Re: **SCI-823-6.81, Portsmouth Bypass Project, PID 19415**  
**Addendum to Report: Shumway Hollow Road (TR 234) Interchange**  
Embankment Stability, Time-Rate of Consolidation, Soil Cut Slope Stability  
DLZ Job No.: 0121-3070.03, Document No. 107

DLZ has reviewed ODOT-Office of Geotechnical Engineering's (OGE's) Stage I review comments (dated January 31, 2007) for Phase 1 of the SCI-823 project. In compliance with the review comments, DLZ has modified the slope stability analyses and time-rate of consolidation calculations for the Shumway Hollow Road (TR 234) interchange embankments. This document also elaborates on our previous recommendations for soil cut slopes and includes the output of the associated stability analyses.

SOIL CUT STABILITY ANALYSIS  
SHUMWAY HOLLOW RAMP D  
STATION 390+00

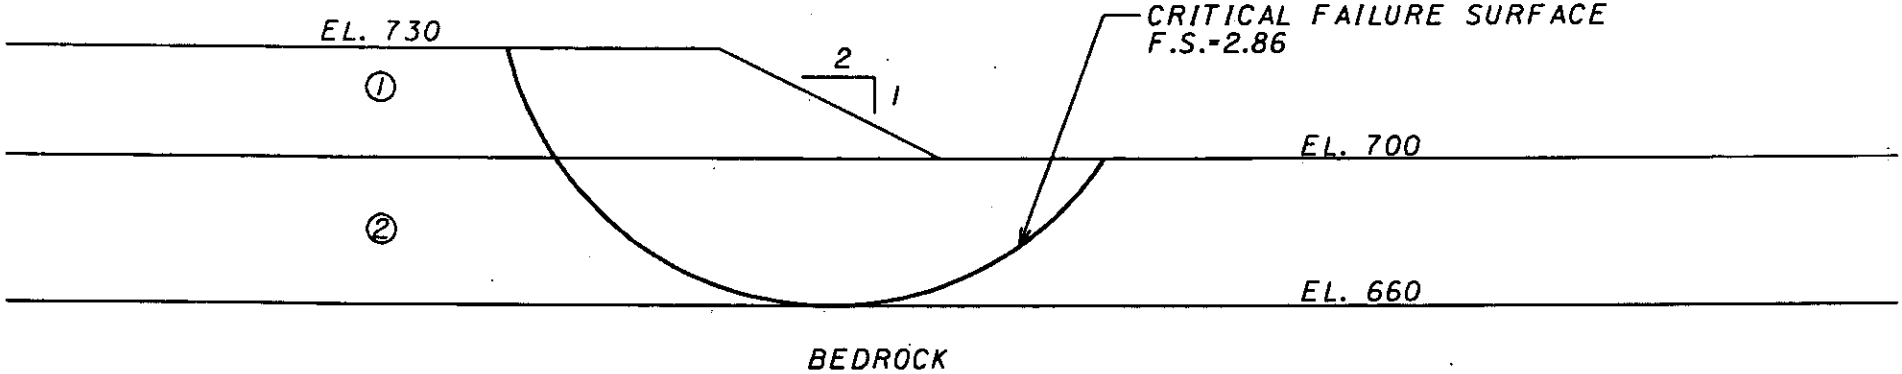
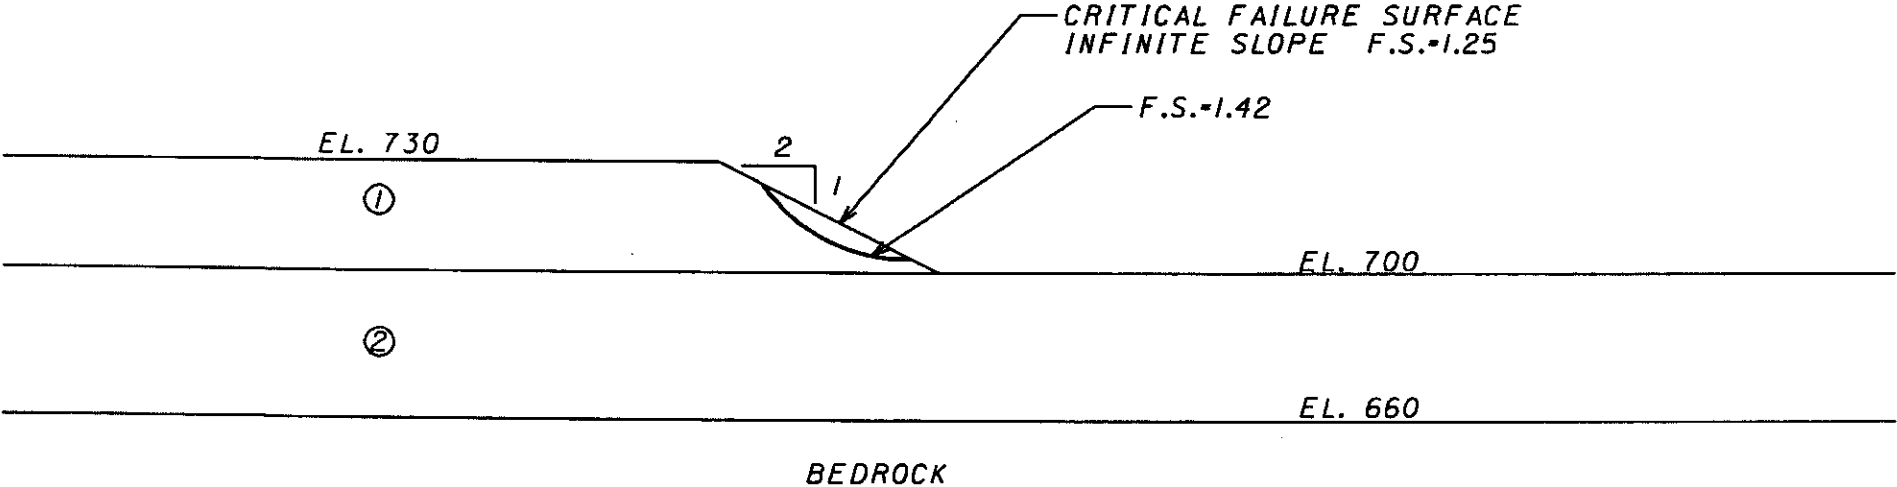
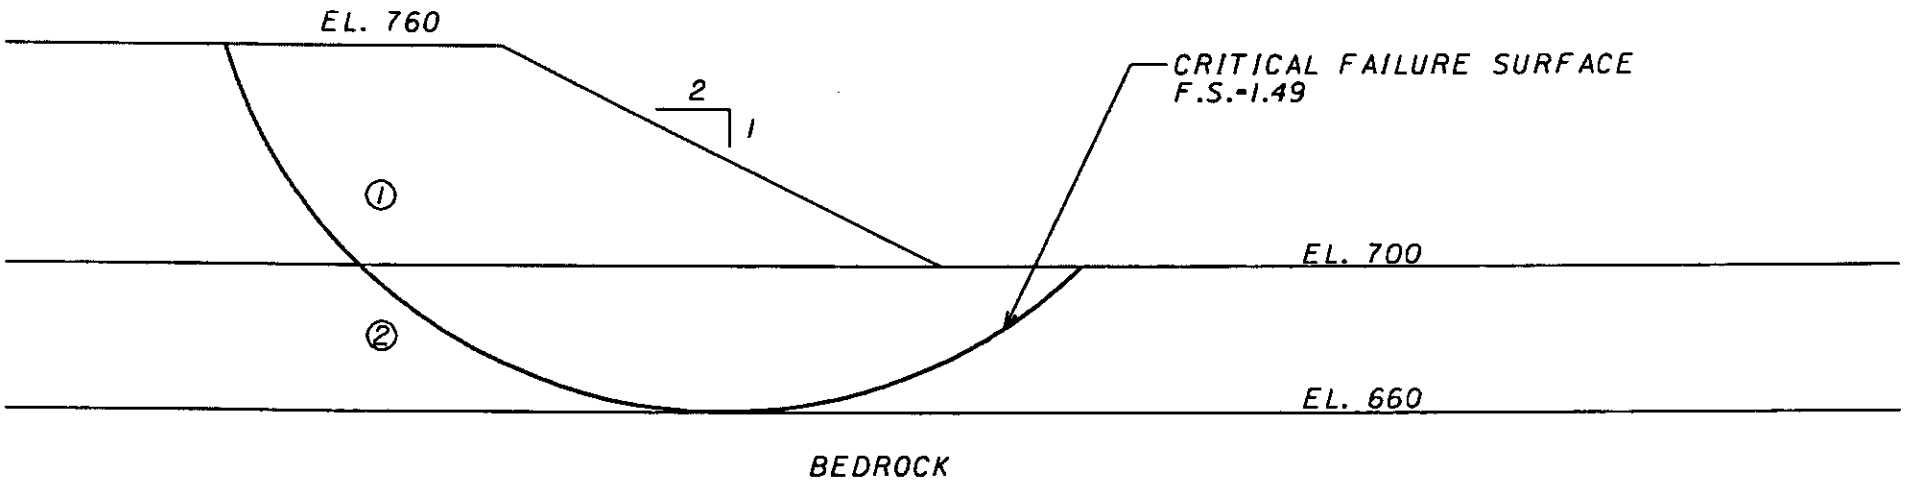
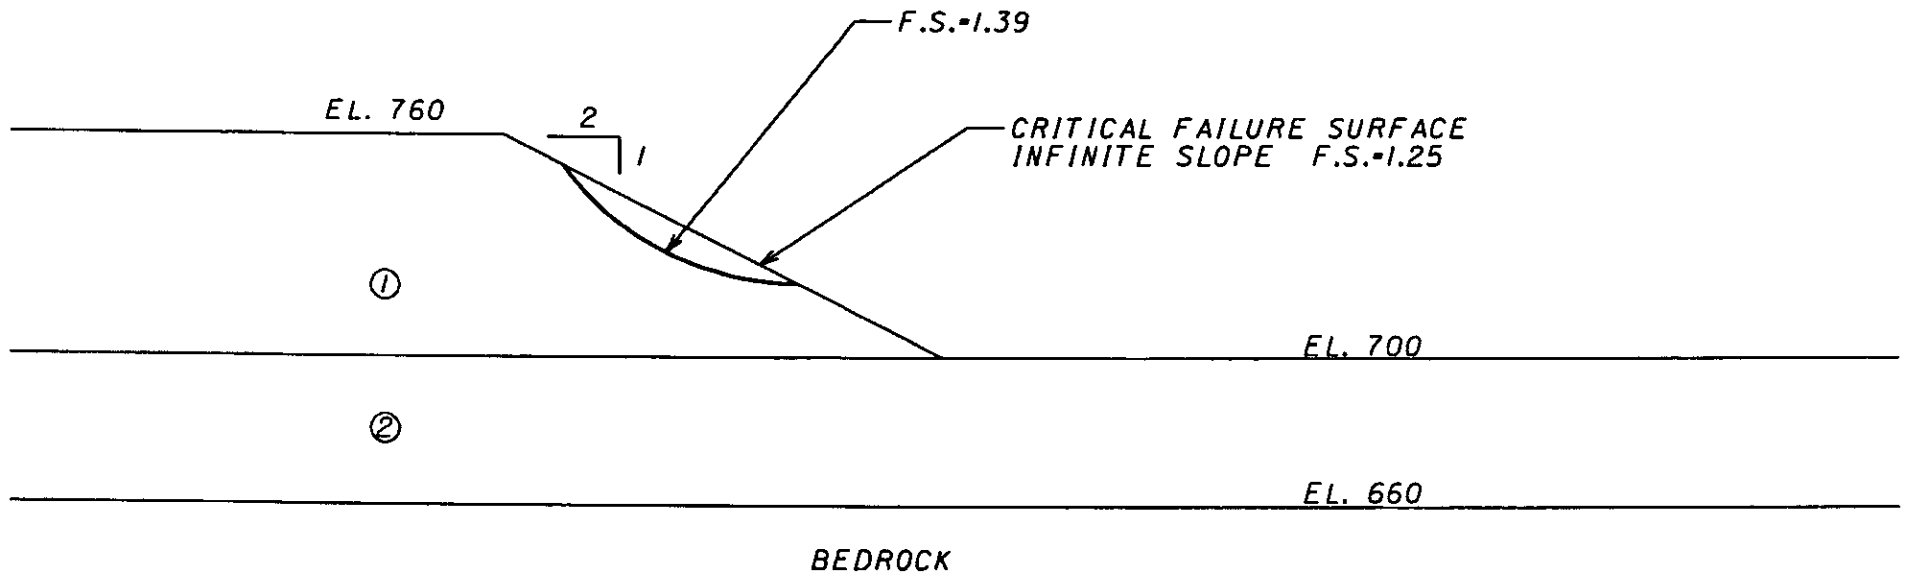
- OGE stated that DLZ evaluate soil cut slopes in the interchange to ensure that the recommended use of 2H:1V slopes in the soil cuts is adequate.

As per OGE's review comments, the stability analyses for the soil cuts in the area of the Shumway Hollow Road (TR 234) Interchange have been reexamined to verify the recommended use of 2H:1V slopes. In the interchange report, a factor of safety of 1.25 for drained condition was determined for 2H:1V slopes. This minimum factor of safety is less than the required factor of safety of 1.30. Upon further examination, it was found that the factor of safety of 1.25 was for an infinite slope type failure. Additional analyses indicate that deeper, specified surfaces yielded factors of safety greater than the minimum required value of 1.30. Consequently, the use of 2H:1V slopes are acceptable. The results of the stability analyses are attached.

- The stability analyses for the soil cut slopes in the interchange area have been examined to verify that the minimum required factor of safety is met. The analyses indicate that 2H:1V slopes in soil cuts are adequate. The results of the stability analyses are attached.
